### **Warragamba Dam Raising State Significant Infrastructure proposal (SSD-8441)**

I refer to the request from Planning and Assessment of 28 September 2021 seeking advice from the Department of Planning, Industry and Environment – Environment, Energy and Science Group (EES) on the Environmental Impact Statement (EIS) for the Warragamba Dam Raising Project.

EES has reviewed the EIS dated 10 September 2021 prepared by SMEC for the proponent WaterNSW. The EES advice is attached to this letter and a summary of the main issues is presented below.

## Department of Planning, Industry and Environment – Environment, Energy and Science Group Detailed Comments

**Figure 1.** Nattai River near the upper end of the current FSL for Warragamba Dam.

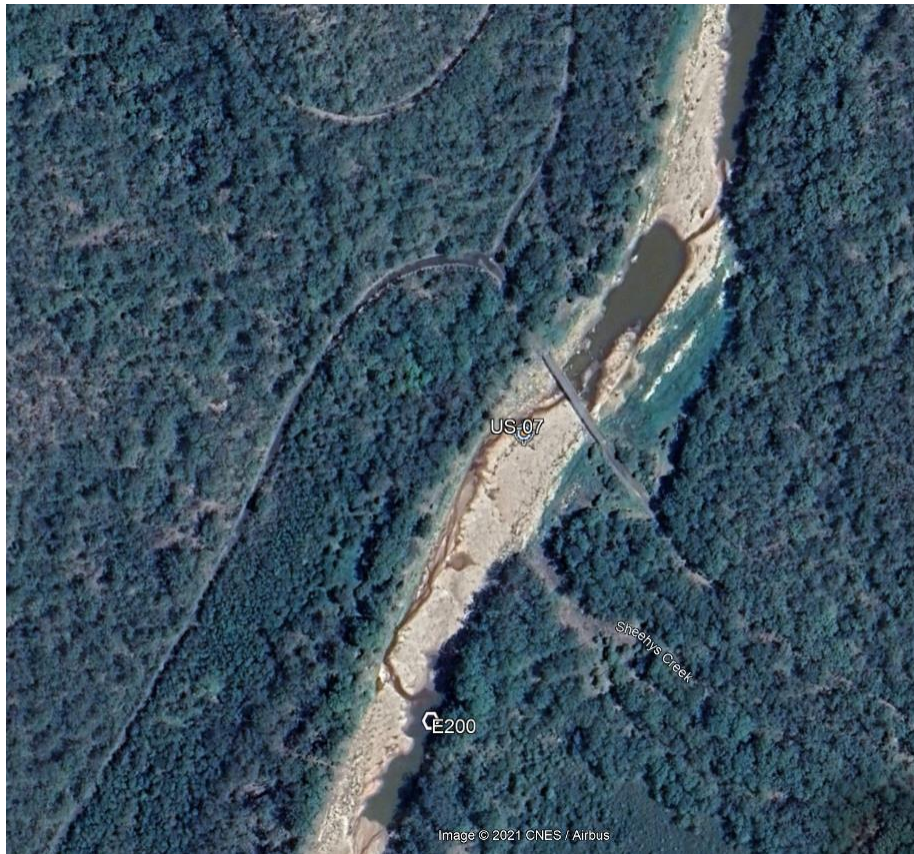
All these effects are readily apparent at the upstream end of the current FSL but have not been appropriately recognised or assessed in the EIS (see Aquatic Ecology Section below). The succession of shoreline communities on previous river margins depends not only on the interplay between erosion and sedimentation of substrates and invasion and extinction of organisms, but also on the duration, timing, and frequency of regulated water levels.

**Figure 4.** Historical dam levels indicating current FSL experiences temporary inundation.

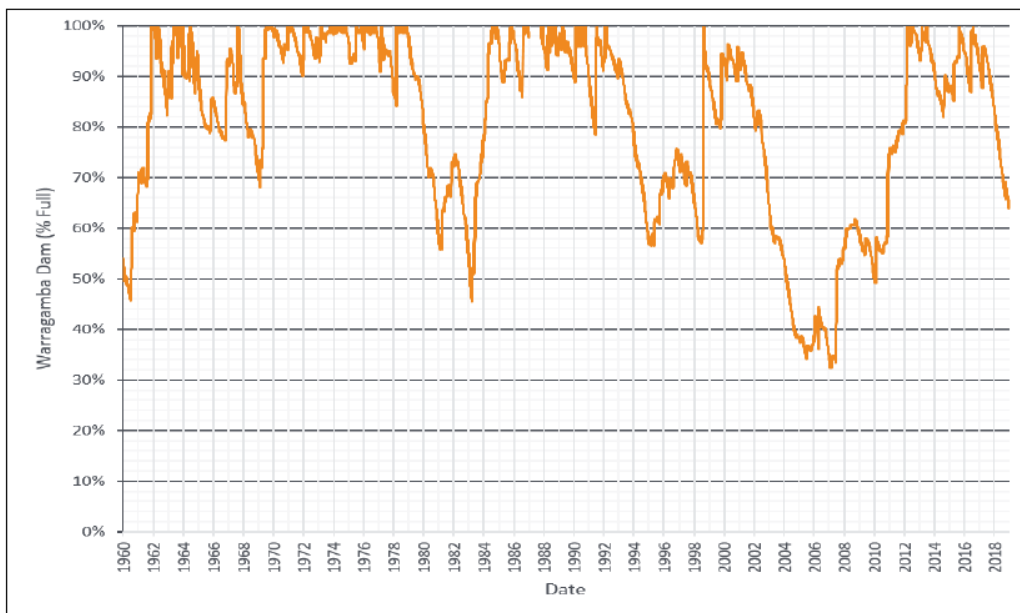
It is notable that these long-lasting and most likely permanent impacts are readily observable, even though the inundation to the current FSL is also temporary (Figure 4).

**Figure 5.** Wollondilly and Jooriland River: Existing FSL, Impact extent and PMF inundation.

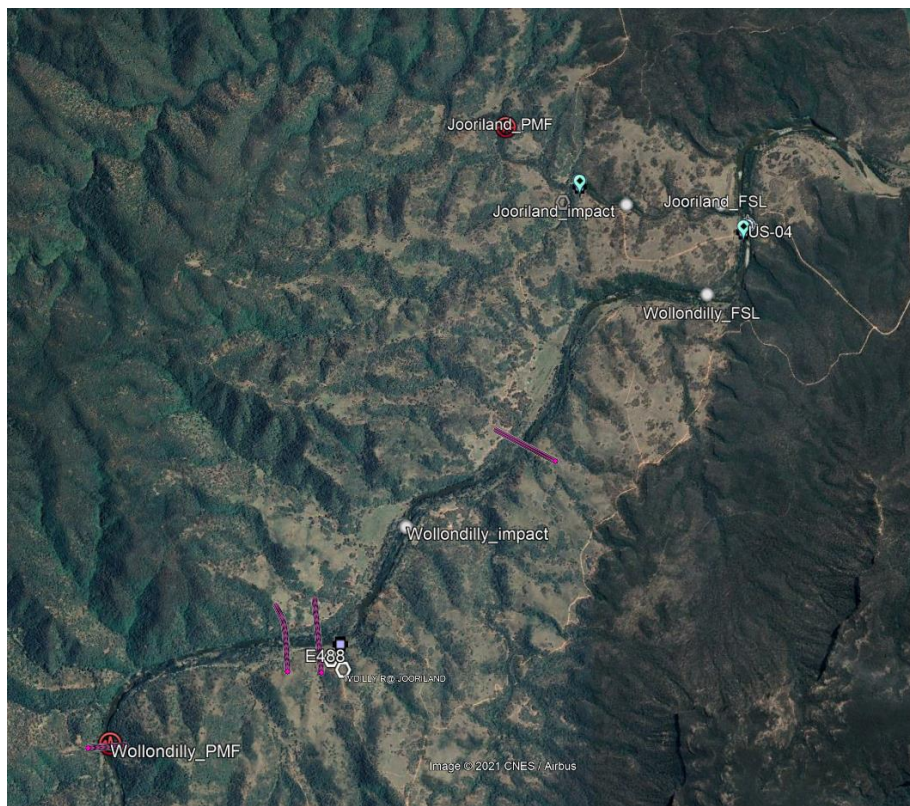
Flood impacts like the current FSL impacts may occur up to the full PMF level in the Wollondilly River - an extension of flood effects to about 9.15 kilometres of river length (see Figure 5).

There is approximately 3.1 kilometres of river length mapped above the Jooriland River junction with the Wollondilly River that is inside the 'new' PMF level. No details were provided in the EIS on inundation levels or duration for Jooriland River. Inundation impacts could occur up to the PMF level in the Jooriland River - an extension of inundation impacts to approximately 3.1 kilometres of river length (see Figure 5).

**Figure 6.** Tonalli River: Existing FSL, Impact extent and PMF inundation.

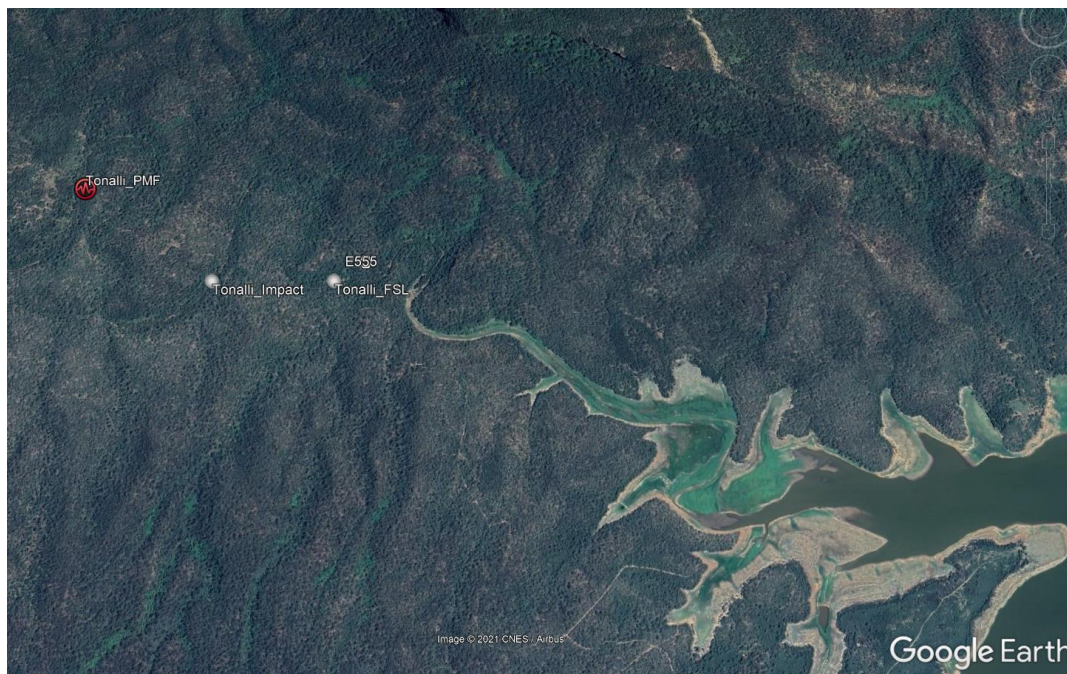
No details were provided in the EIS on inundation level or duration for the Tonalli River. Inundation impacts like the existing impacts of the current FSL may occur up to the full PMF level in the Tonalli River - an extension of inundation impacts to approximately 4.5 kilometres of river length (see Figure 6).

**Figure 7.** Nattai and Little River: Existing FSL, Impact extent and PMF inundation.

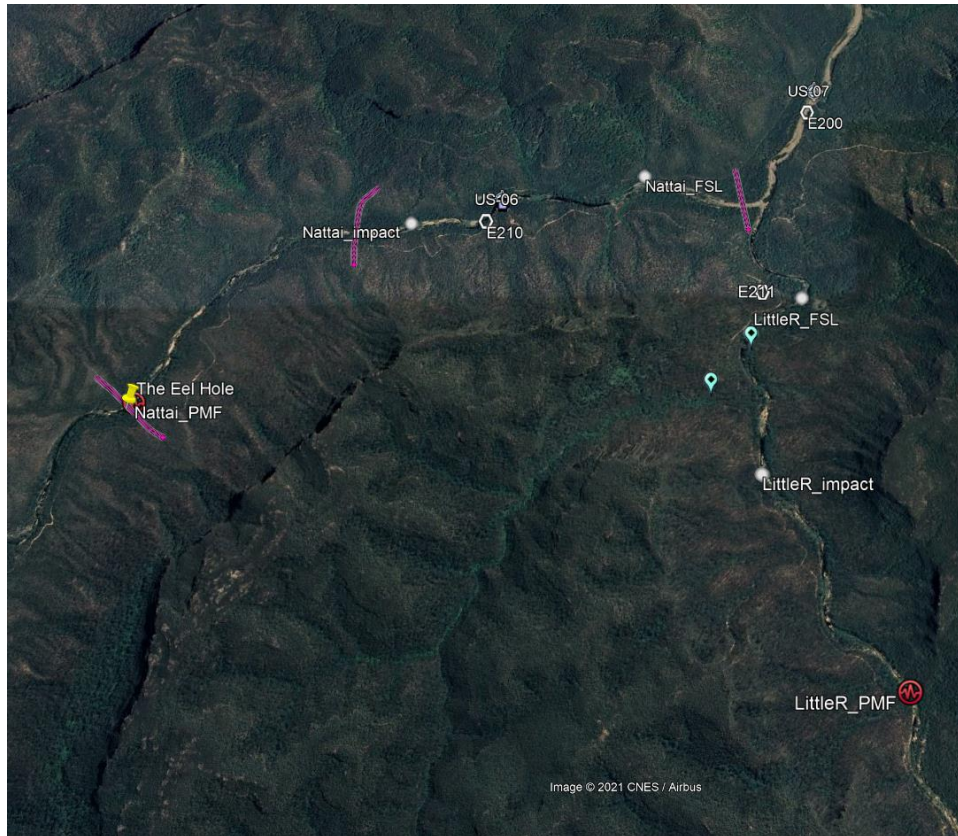
This indicates that there will be significant inundation occurring in the Nattai River. There is approximately 5.1 kilometres of river length mapped above the FSL that is inside the 'new' PMF level for the Nattai River (see Figure 7). The upper end of the PMF appears to coincide with the *Eel Hole* cited as a resting place of *Gurangatch* in the Aboriginal creation story of the area<sup>4</sup>. Inundation impacts like the existing impacts of the current FSL may occur up to the PMF in the Nattai River.

There is approximately 2.6 kilometres of river length mapped above the FSL that is inside the 'new' PMF level for Little River. No details were provided in the EIS on inundation level or duration for the Little River. Inundation impacts like the existing impacts of the current FSL may occur up to the full PMF level in the Little River - an extension of inundation impacts to approximately 2.6 kilometres of river length (see Figure 7).

**Figure 9.** Green Wattle Creek: Existing FSL, Impact extent and PMF inundation.

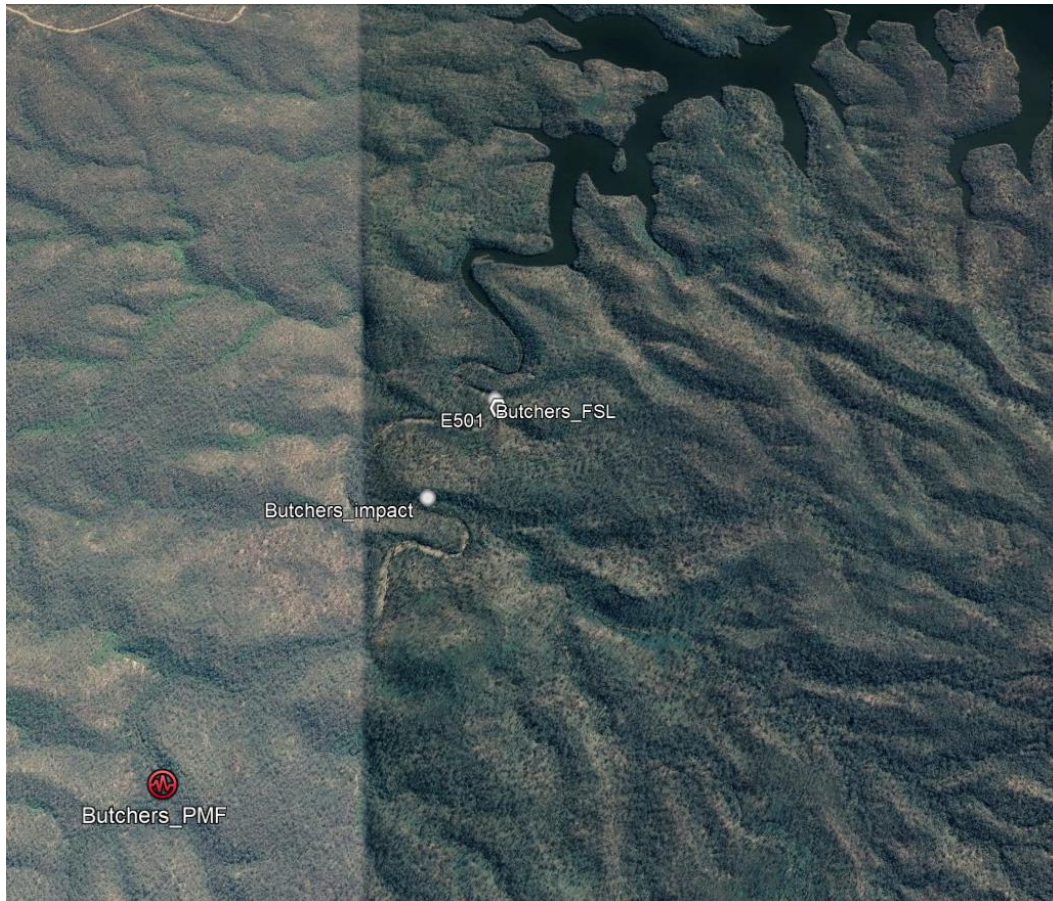
There is approximately 4.65 kilometres of river length mapped above the FSL that is inside the 'new' PMF level for Green Wattle Creek. No details were provided in the EIS on inundation level or duration for Green Wattle Creek. Inundation impacts like the existing impacts of the current FSL may occur up to the full PMF level in Green Wattle Creek, an extension of inundation impacts to approximately 4.65 kilometres of stream length (Figure 9).

**Figure 12.** Kedumba River and Reedy Creek: Existing FSL, Impact extent and PMF inundation.

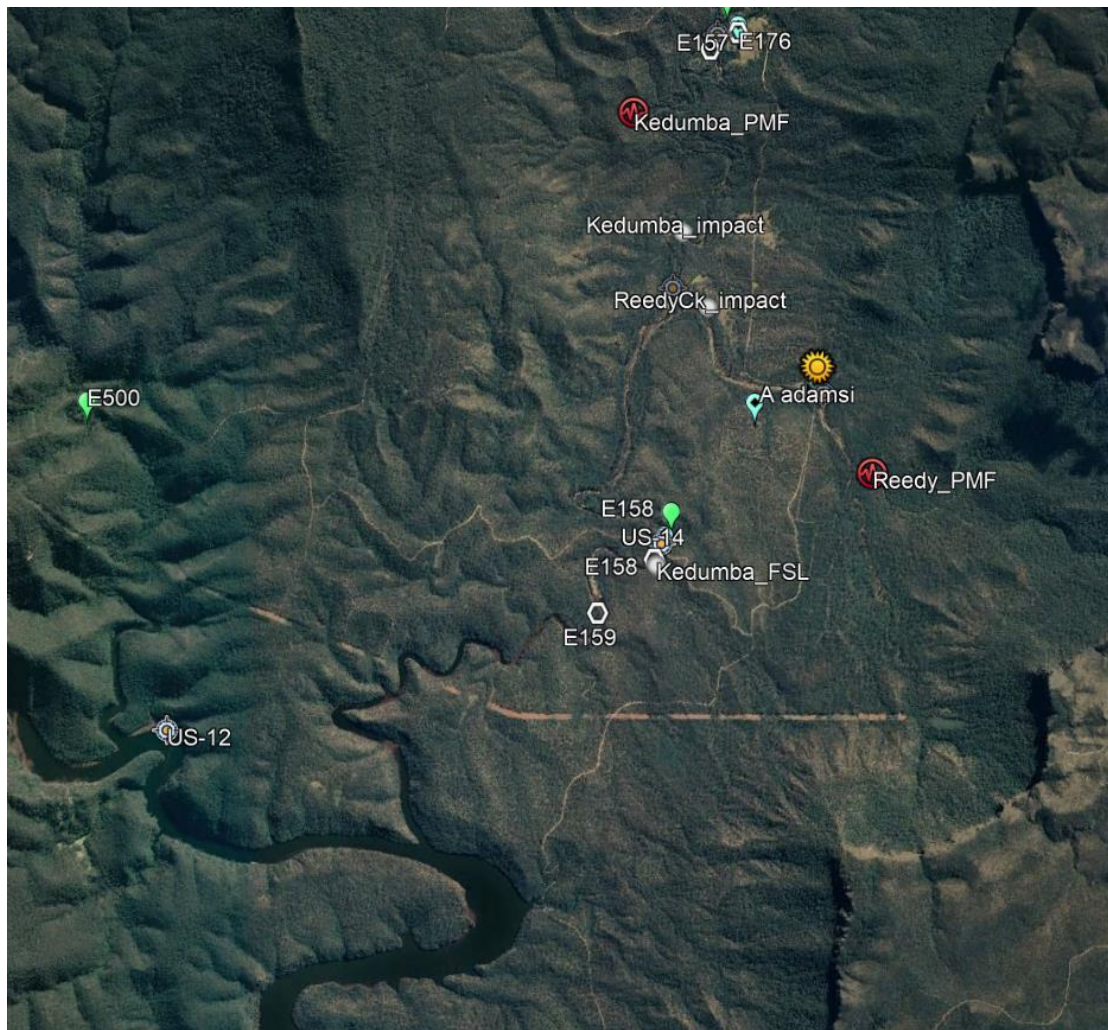
There is approximately 6.4 kilometres of river length mapped above the FSL that is inside the 'new' PMF level for the Kedumba River. No details were provided in the EIS on inundation level or duration for Kedumba River. Inundation impacts like the existing impacts of the current FSL may occur up to the full PMF level in Kedumba River (see Figure 12). Only the Coxs River and Wollondilly River are likely to have a larger inundation impact zone than the Kedumba River.

There is approximately 2.3 kilometres of river length mapped above the FSL that is inside the 'new' PMF level for Reedy Creek. No details were provided in the EIS on inundation level or duration for Reedy Creek. Inundation impacts like the existing impacts of the current FSL may occur up to the full PMF level in Reedy Creek - an extension of inundation impacts to approximately 2.3 kilometres of stream length (see Figure 12).

**Figure 13.** Cedar Creek: Existing FSL, Impact extent and PMF inundation.

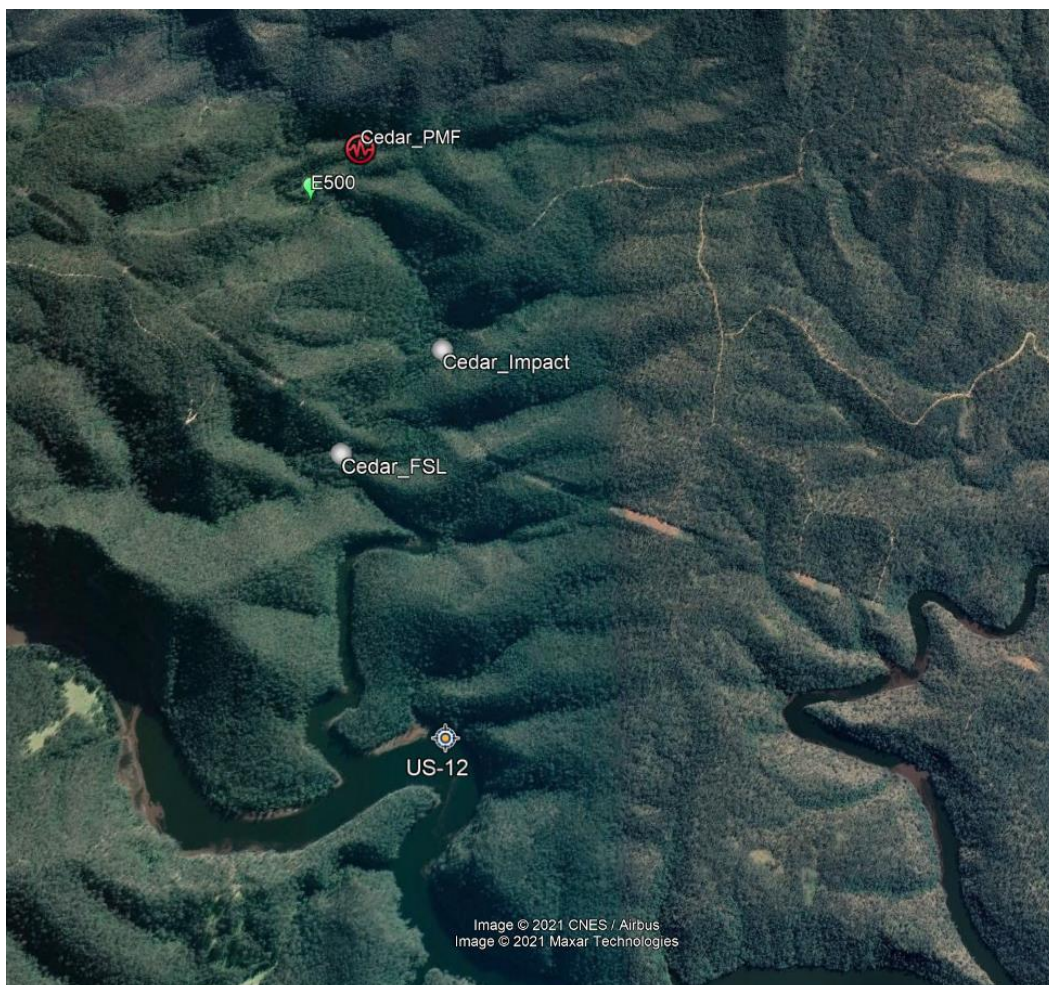
There is approximately 3.4 kilometres of stream length mapped above the FSL that is inside the 'new' PMF level for Cedar Creek, located approximately 900m downstream of the Berrima Inga Creek confluence. No details were provided in the EIS on inundation level or duration for Cedar Creek. Inundation impacts like the existing impacts of the current FSL may occur up to the full PMF level in Cedar Creek - an extension of inundation impacts to approximately 3.4 kilometres of stream length (see Figure 13).

**Figure 14.** Kowmung River: Existing FSL, Impact extent and PMF inundation.

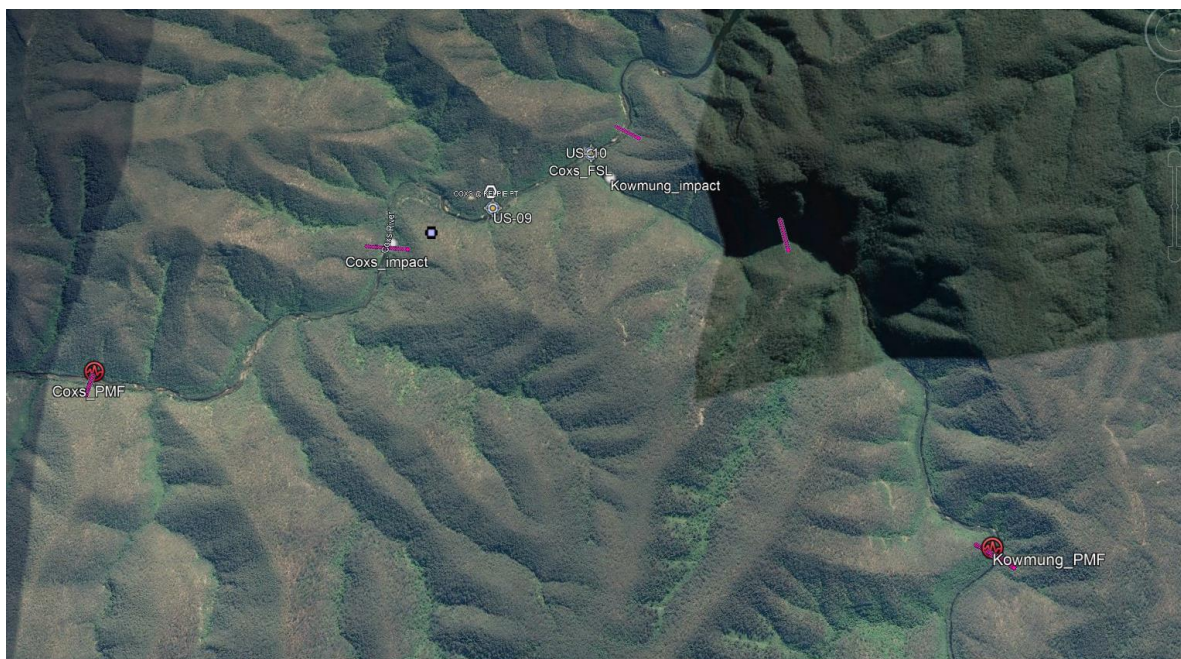
Inundation impacts like the existing impacts of the current FSL may occur up to the full PMF level in the Kowmung River - an extension of inundation impacts to approximately 4.7 kilometres of river length (see Figure 14).

**Figure 16.** Location of Adam's Emerald Dragonfly (*Archaeophya adamsi*) in Reedy Creek relative to existing FSL, Impact extent and PMF inundation.

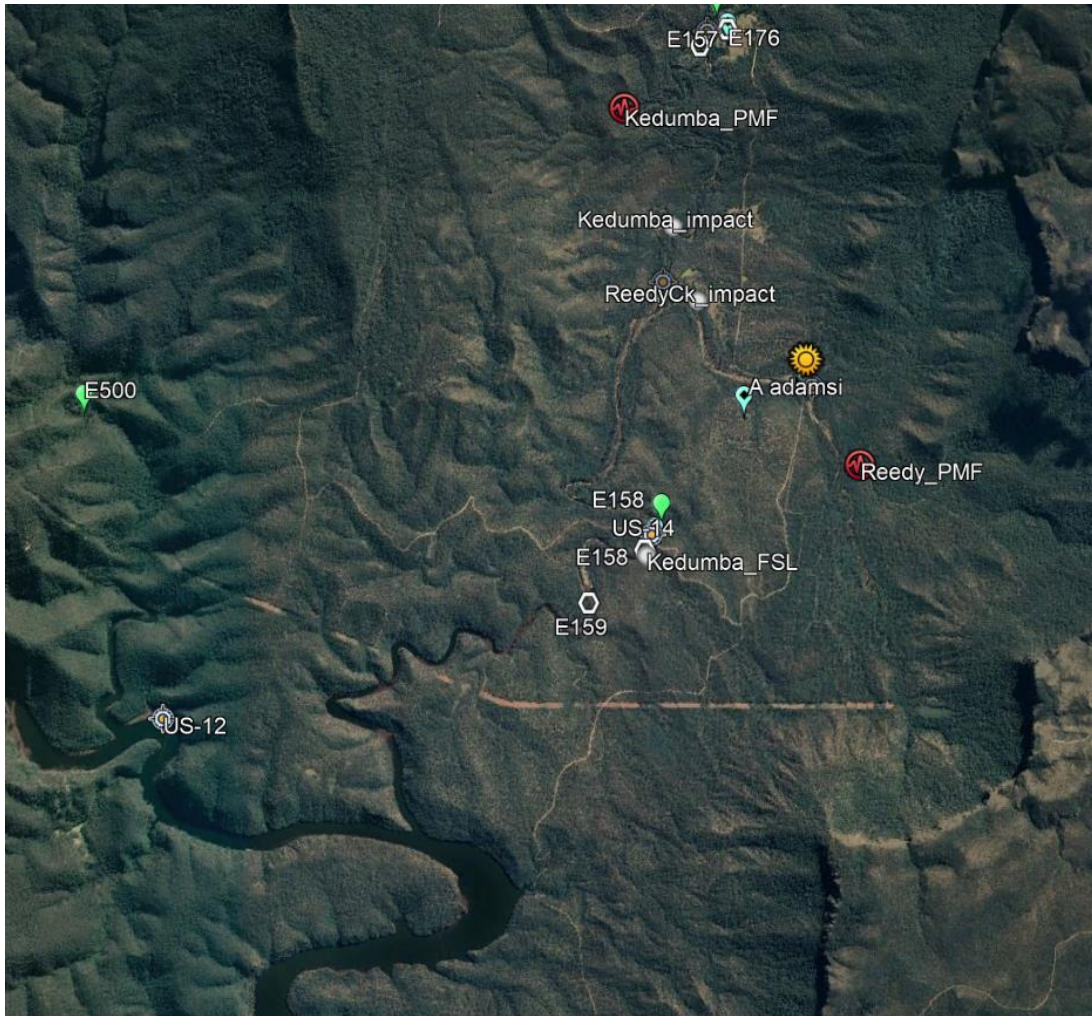
The Aquatic Ecology Assessment has failed to adequately survey the scientific literature in relation the Adam's Emerald Dragonfly. Further, no targeted sampling for the species has occurred. The Aquatic Ecology Assessment is considered deficient in its sampling and assessment of Adam's Emerald Dragonfly populations likely to be impacted by the project.
